Executive Director's Recommendation

Commission Meeting: June 7, 2012

PROJECT Phase 1 (North Campus) Intelligence Community Campus--Bethesda 4600 Sangamore Road Bethesda, Maryland	NCPC FILE NUMBER 7326
SUBMITTED BY United States Army Corps of Engineers on behalf of the Defense Intelligence Agency	NCPC MAP FILE NUMBER 3101.10(38.00)43567
REVIEW AUTHORITY Federal Projects in the Environs per 40 U.S.C. § 8722(b)(1)	APPLICANT'S REQUEST Preliminary and final approval of site and building plans
	PROPOSED ACTION Approve with conditions
	ACTION ITEM TYPE Staff presentation

PROJECT SUMMARY

Figure 9: Garage sixth-level plan. The garage has a four-bay layout with the ramp contained in one central bay. At the sixth-level the ramp is covered with a roof structure, creating a penthouse, which will hold a photovoltaic array.

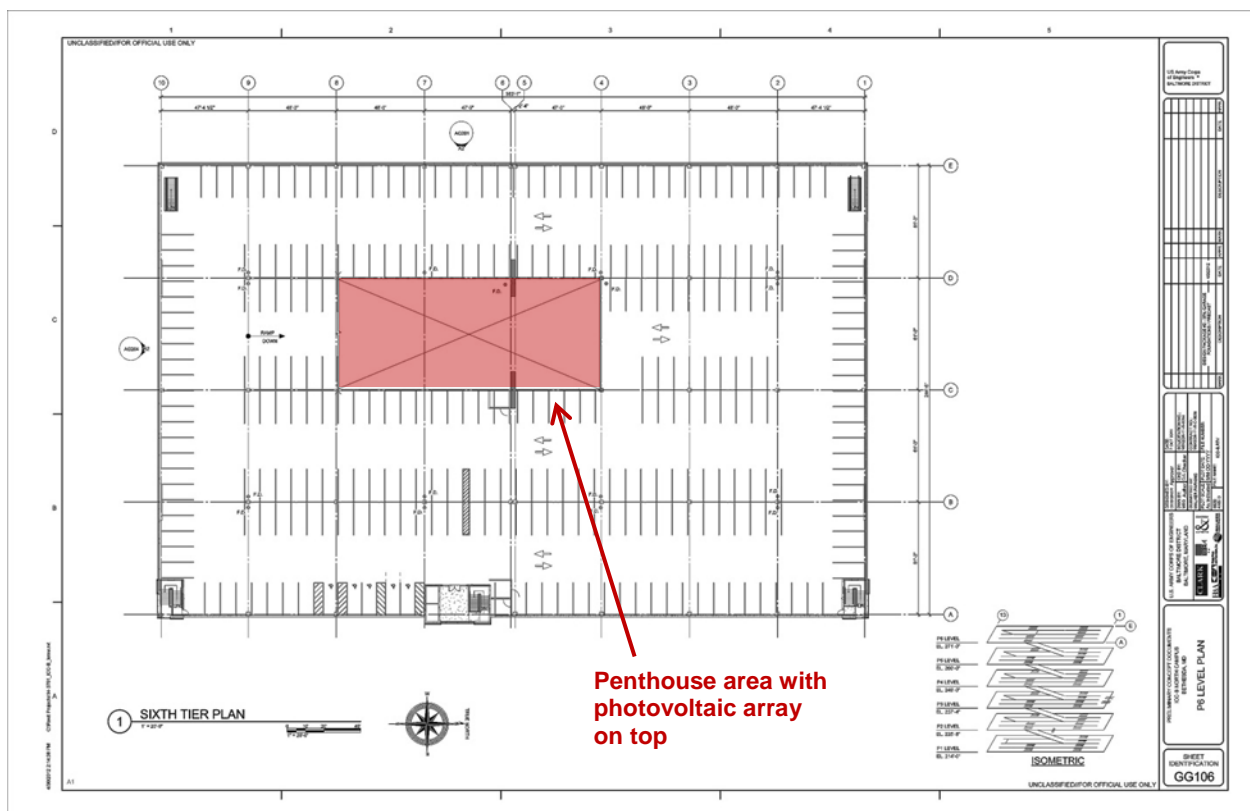
A penthouse structure is proposed to support the PV array. Located within the central area of the upper (sixth) level and with a height of 10 feet (not including the PV array itself) above the top

parking level of garage, and due to the area topography and approximate 4-foot parapet at the top garage level, the penthouse structure will be difficult to view from the ground level.³ In particular, from the west and south sides the ground slopes down dramatically which would result in the inability to see the penthouse structure from ground level. From the east, portions of the penthouse structure may be visible from Sangamore Road, however, the garage's parapet and central stair tower on its west façade, as well as other site structures and landscaping would make it minimally visible at this location.

Figure 15: Storm water management plan.

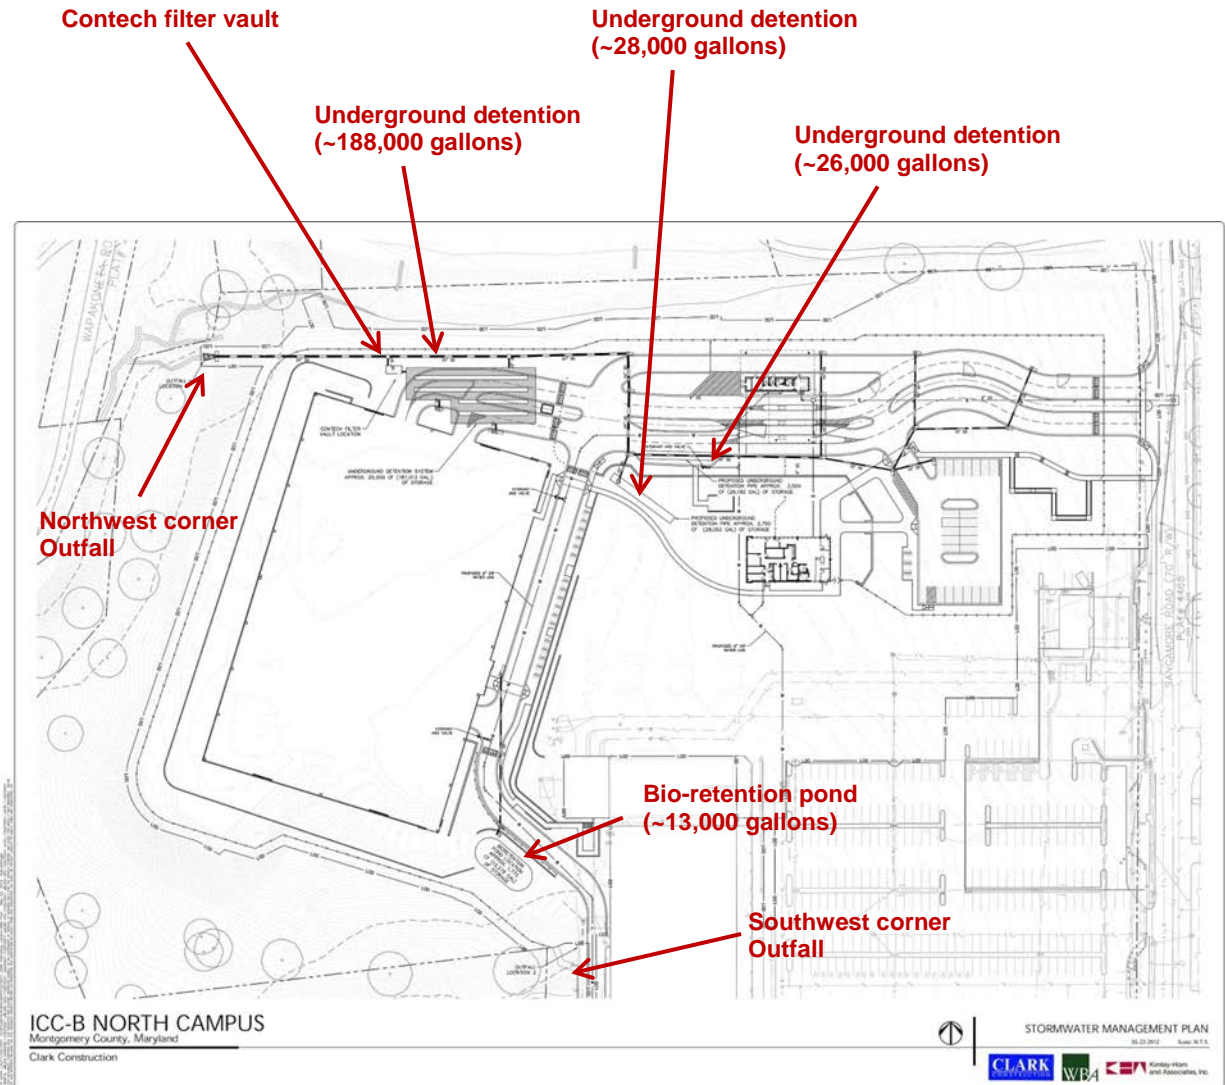
There appears to be general agreement among the USACE, DIA, community and staff that site and budgetary constraints make the design standard of treating and retaining 100 percent of storm water for a 25-year storm unfeasible. However, the applicant has designed a storm water detention system that will exceed the 10-year storm requirements of MDE and that will filter and control the rate of flow of detained storm water from the site (as described above the North Campus storm water management plan uses both a bio-retention pond and engineered filters to treat storm water released from the site).

The complete North Campus storm water management design is currently scheduled to be submitted to MDE in late June 2012. Though not yet completely engineered, the summary and intent of this plan is displayed in the Storm Water Management summary drawing (above). This drawing represents a continuous progression from the intent stated during the April 2012 informational briefing provided to the Commission. The current design accounts for treatment of water from all areas of the North Campus. To do this, the proposed detention structure north of the garage has been significantly increased in capacity over the original permit design and the proposed treatment pond in the southeast corner of the garage exceeds the size and treatment capacity that would otherwise be required by MDE. (Through further engineering and discussions with MDE, the proposed

treatment pond has recently been reduced in size, while still at a desired capacity, that may allow for an in-the-field reduction of the number of trees affected by construction.)
